AUDIT FINDINGS AND RECOMMENDATIONS

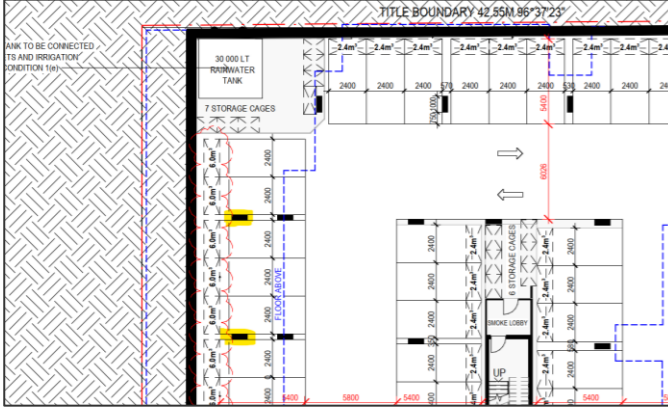
<p>2. Radii are provided at the bottom of ramps between levels, but not at the top (yellow highlight vs pink highlight below). This could affect the ability to accommodate passing movements at the top of the ramp. Additionally sightlines may be affected by the wall either side of the ramp.</p> 	<p>Confirm by means of a swept path assessment to confirm that circulating vehicle movements can be suitably accommodated. (P)</p> <p>Review sightlines at this location and adjust wall if needed and if possibly to improve sightlines. (P)</p> <p>If the walls cannot be adjusted, supplementary convex mirrors should be provided to assist with sightlines. (S)</p>	<p>Rare Insignificant Negligible</p>	<p>Within Tolerable</p>	<p>Radii have not been provided however ramp has been increased from 5.5 m to 6.7 m. Swept paths should be checked to ensure appropriate design vehicle movements can be accommodated.</p> <p>Convex mirrors are not shown at all intersections. Review sightlines and add convex mirrors if necessary.</p>	<p>Swept path assessment confirms that circulation can be provided for concurrent B85 and B99 design vehicle movements.</p> <p>Convex mirrors should be provided at each side of the ramp on all basement levels.</p>

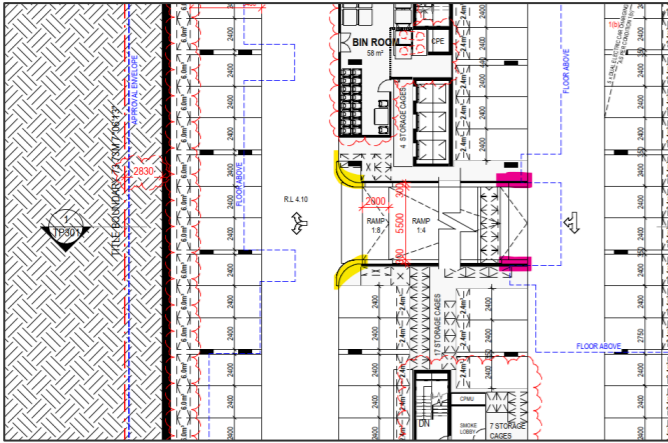
Audit Findings	Recommendations (P) Primary (ST) Step Towards (S) Supporting (N) Non Safe-System	Level of Risk	Safe System Energy	Revised / Updated Audit Finding Based on Review of P10 Plans	Designer/Project Manager Response
<p>3. Vehicles are unlikely to be able to pass at the corners and intersections within the basement levels, creating opportunities for side swiping.</p>	<p>Install convex mirrors to assist with driver sightlines. (S)</p>	<p>Rare Insignificant Negligible</p>	<p>Within Tolerable</p>	<p>Convex mirrors have been added in some locations but not others.</p> <p>Check swept paths and add convex mirrors at all locations where concurrent passing movements are not possible and sightlines to oncoming vehicles may be compromised.</p>	<p>Convex mirrors are provided at all corners of each basement level.</p>
<p>4. The pedestrian sight triangle on the western side of the access driveway is compromised by the column within the prescribed area. It is acknowledged that the Planning Scheme requirement is for the prescribed area to be 'at least 50% clear of obstructions', which is technically achieved by the proposed solution, it is considered that the 50% requirement is to allow for treatments such as paling fences which wouldn't completely obscure the view to a pedestrian.</p> <p>It is acknowledged that a convex mirror is provided to assist with sightlines, however that should be considered a supplementary treatment if it is not possible to remove the issue entirely. The convex mirror appears to be installed behind the pedestrian entry door and will therefore need to be installed at a height that doesn't obstruct access. This will likely not be visible to drivers exiting the site.</p> 	<p>Review options to reduce obstructions within the pedestrian sight triangle on the western side of the driveway. This could include a column immediately to the east of the driveway (noting that the Planning Scheme acknowledges that a sight triangle on the entry side of an access is less important. (P)</p> <p>Review the positioning of the convex mirror to ensure that it can function suitably (ST)</p>	<p>Rare Minor Negligible</p>	<p>Within Tolerable</p>	<p>Finding still applicable to revised plans.</p>	<p>Pedestrian sight triangle will be partially clear of obstruction, and glazed to allow visibility between drivers exiting the site and pedestrians approaching the driveway from the west.</p> <p>Convex mirrors on both sides of the access will mitigate any potential loss in visibility.</p>

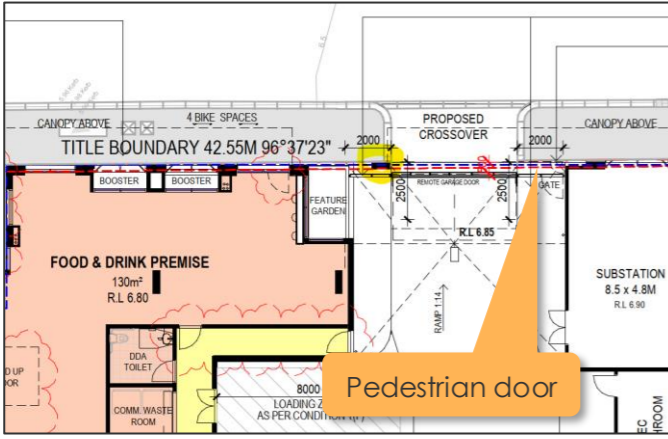
Audit Findings	Recommendations (P) Primary (ST) Step Towards (S) Supporting (N) Non Safe-System	Level of Risk	Safe System Energy	Revised / Updated Audit Finding Based on Review of P10 Plans	Designer/Project Manager Response
<p>5. The spaces for the café and food and drink premises feature a shared area between them, so that they could be used by people with disabilities, should they have the need to.</p> <p>While not necessarily a safety concern, there it is suggested that storage cages over the end of these spaces could make them more difficult to use for people with disabilities. Additionally while Australian Standard 2890.6:2022 does allow for a column to be located within the shared area, the column shown on the plans does not fall within the area permitted under the standard.</p> 	<p>Consider the design of these spaces with regard to the requirements of AS 2890.6:2022. (N)</p>	<p>Note</p>	<p>Not Applicable</p>	<p>Storage cages no longer provided in these spaces.</p> <p>Column is still located within the shared area and should be addressed.</p>	<p>If structural design permits, the column should be relocated centrally within the hatched area.</p> <p>This is considered a building compliance matter, and does not materially impact safety.</p>

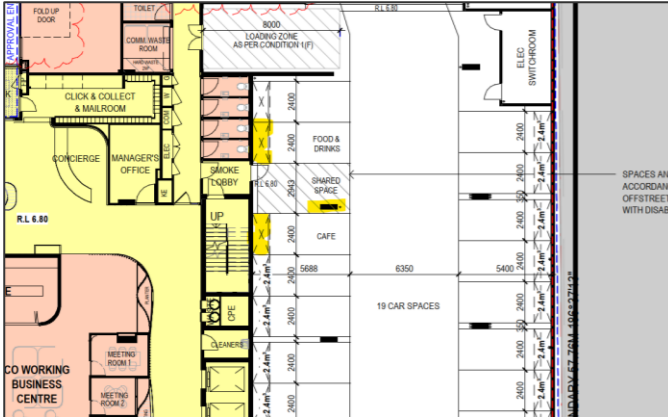
<p>6. The roller door opening at the site entrance has a width of 5.5 m. The 5.5 m width should allow for entering and exiting cars to pass one another however there would be minimal clearances to the vehicles. A 6.1 m door width would be preferable.</p>	<p>Undertake a swept path assessment to confirm suitable access to the site and simultaneous entering and exiting vehicles (ST)</p>	<p>Possible Insignificant Low</p>	<p>Within Tolerable</p>	<p>Finding remains applicable to revised plans.</p>	<p>Swept path diagrams indicate the access can permit concurrent entry and exit manoeuvres for two waste vehicles, which is more than adequate to accommodate two passing passenger cars.</p>
<p>7. The remote garage door is positioned at the site boundary to Sutton Street and will result in vehicles propping within the crossover and onto the Sutton Street carriageway while the door is opening. It is acknowledged that Sutton Street would be expected to carry low traffic volumes in this area, being a no-through road, and the wide carriageway will ensure that through traffic can still pass. Nonetheless, multiple vehicles waiting to enter the site will project queues into the through traffic on Sutton Street and may present a risk of collisions.</p>	<p>Recess the garage door into the site to ensure that there is adequate space for entering vehicles to queue/prop while the door is opening (P) Review door opening mechanisms to ensure minimal delay for opening (S)</p>	<p>Unlikely Minor Low</p>	<p>Within Tolerable</p>	<p>Finding remains applicable to revised plans.</p>	<p>Given the limited traffic generated by the site, it is expected vehicles will rarely be queueing on-street.</p> <p>The developer should incorporate a suitable high-speed door to service the access.</p>
